COMMERCIAL RETAIL STORE
 ROANOKE COUNTY
 WILLIAMSON ROAD
 ROANOKE COUNTY, VIRGINIA

DATE: 10-31-2017
 DRAWING TITLE: STORM SEWER SYSTEM
 SCALE: 1"=20'
 SHEET NO. C04

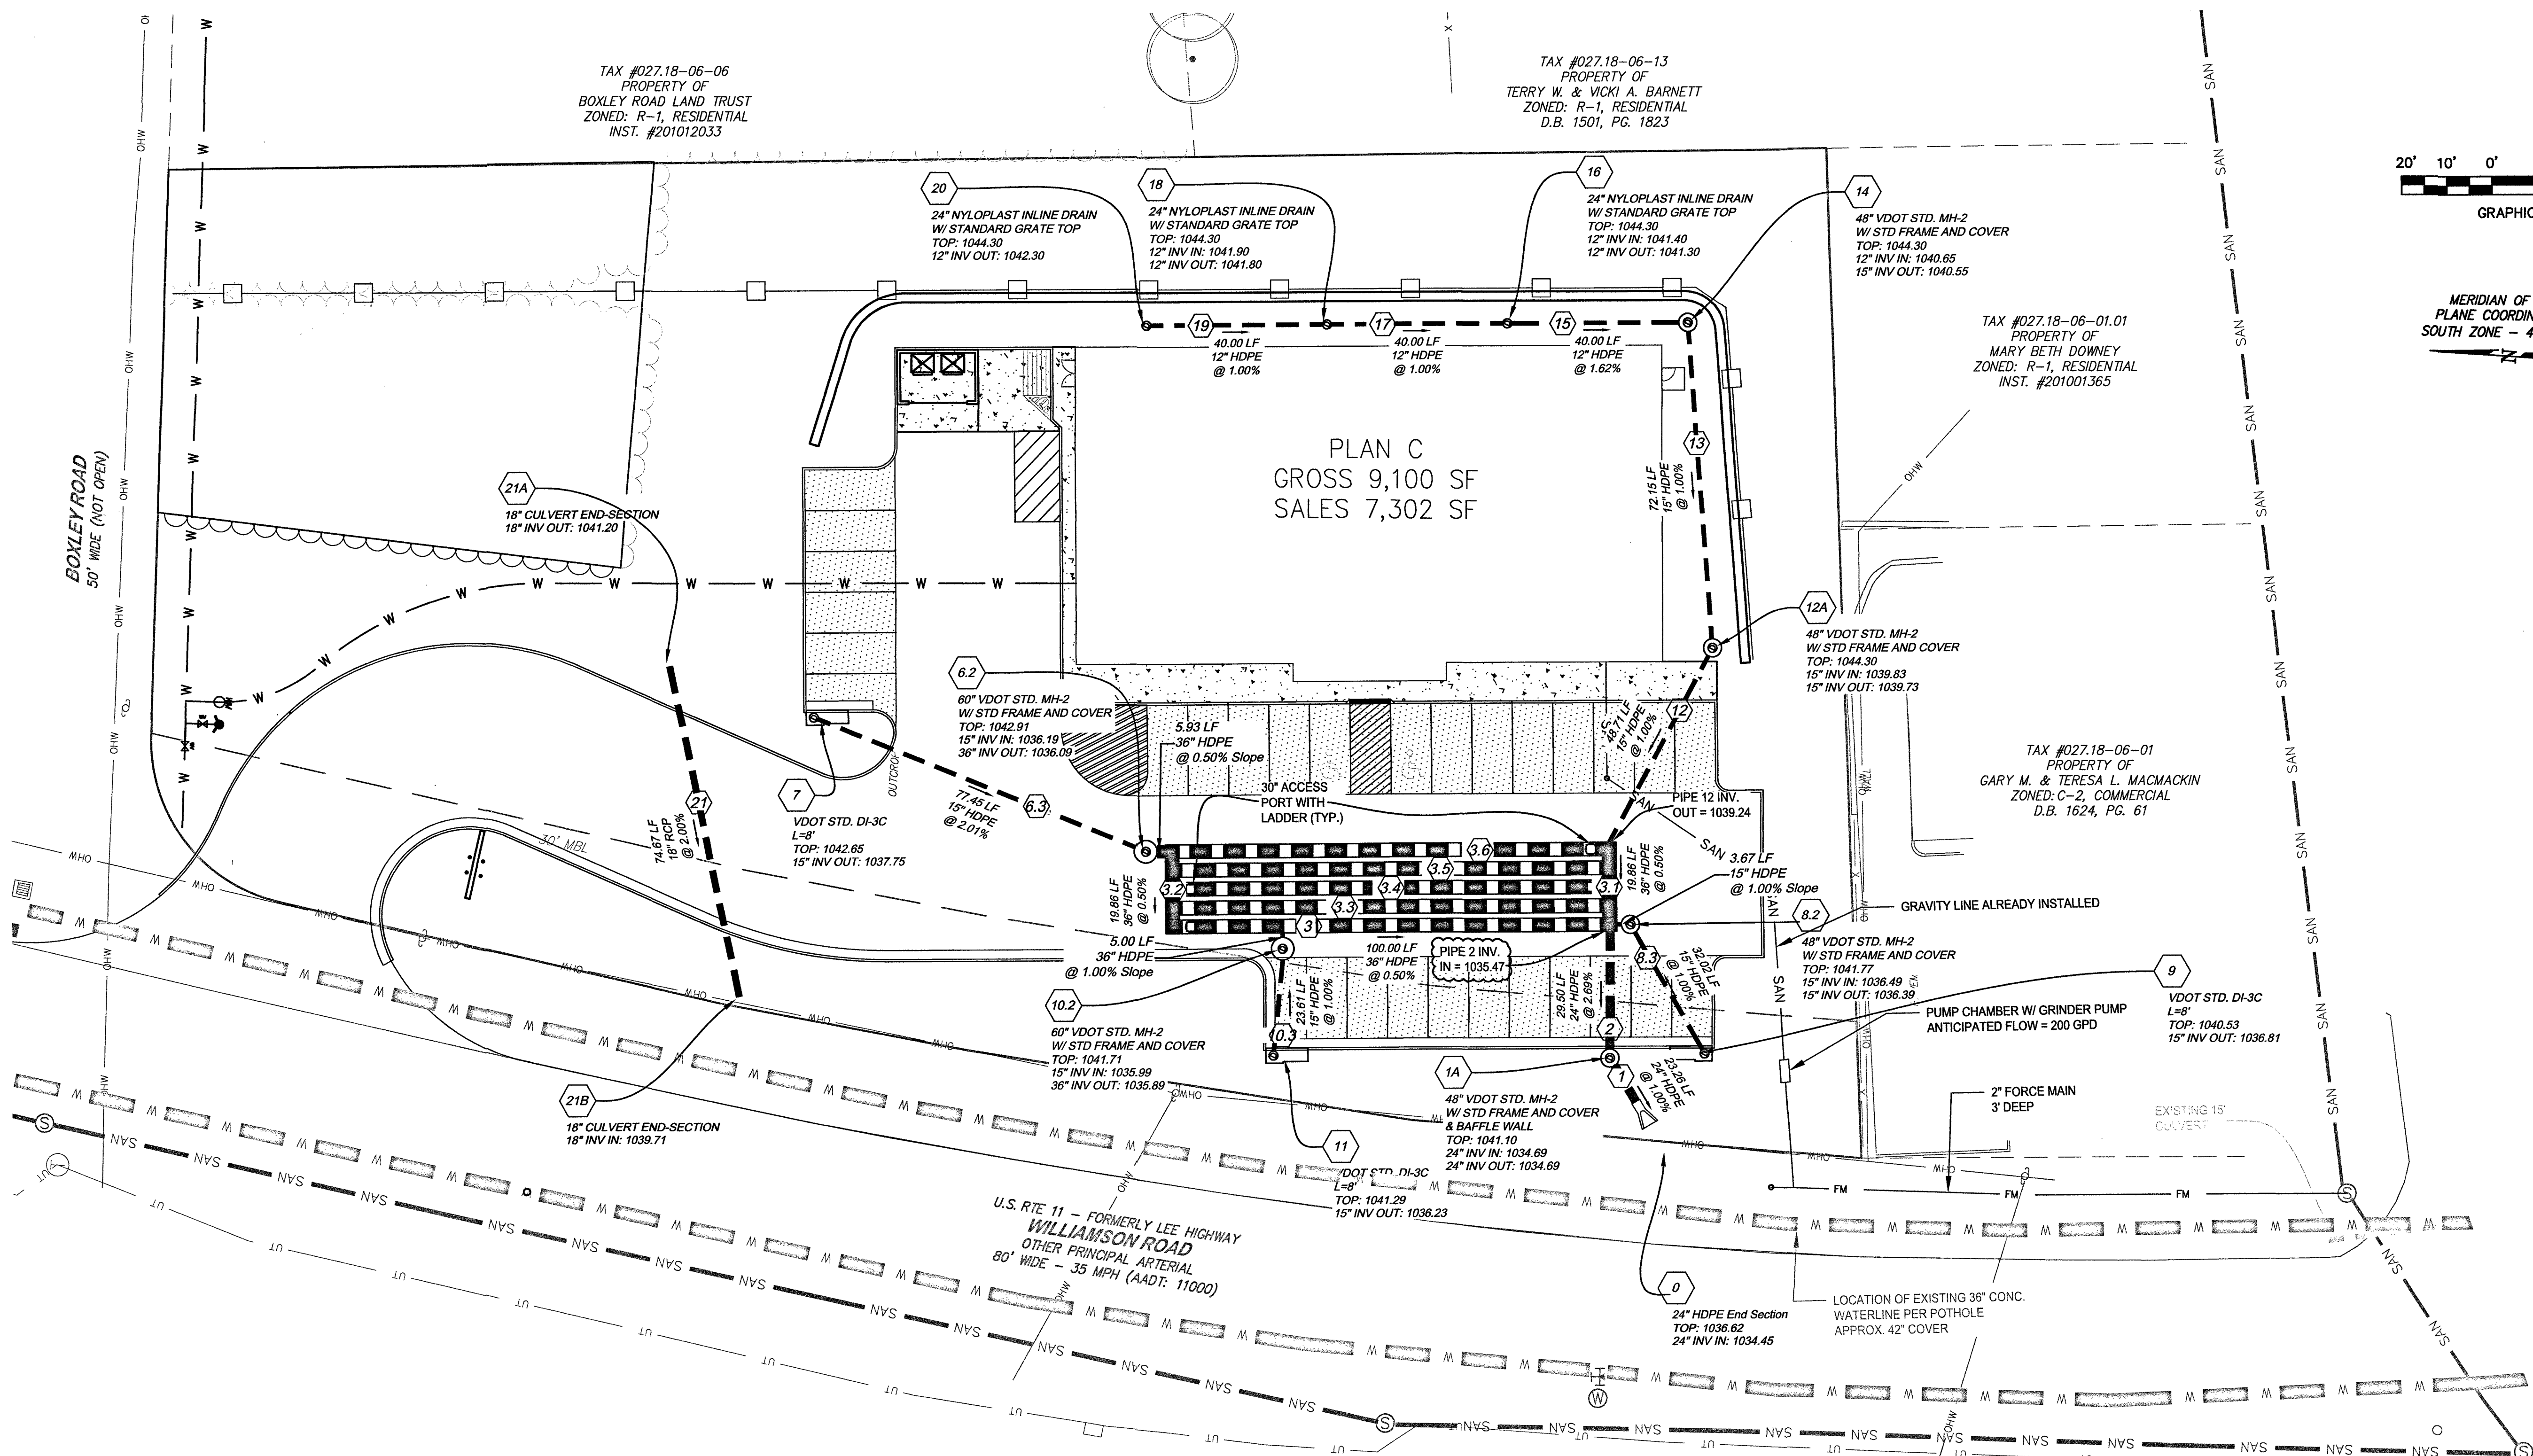
FIELD REVISION #1 AS OUTLINED (4/14/17):
 1. BUILDING PAD AND PARKING LOT RAISED UP TO 0.5'. GRADING PLAN REVISED.
 2. COMMERCIAL ENTRANCE PROFILE REVISED TO ALLOW BUILDING ELEVATION CHANGES.
 3. UPDATED STAGE STORAGE VOLUME TABLE TO REFLECT NEW SYSTEM ELEVATIONS.
 FIELD REVISION #2 AS OUTLINED (5/30/17):
 1. REVISED WALL DESIGN BEHIND BUILDING.
 FIELD REVISION #3 AS OUTLINED (9/18/17):
 1. REVISED WALL DESIGN BEHIND BUILDING.
 FIELD REVISION #4 AS OUTLINED (10/31/17):
 1. REVISED FORCE MAIN WITH ADDITION OF CAP, TEE, AND LATERAL PRESSURE ASSEMBLY.
 FIELD REVISION #5 AS OUTLINED (11/06/17):
 1. REVISED ENTRANCE LOCATION AND CULVERT 21.
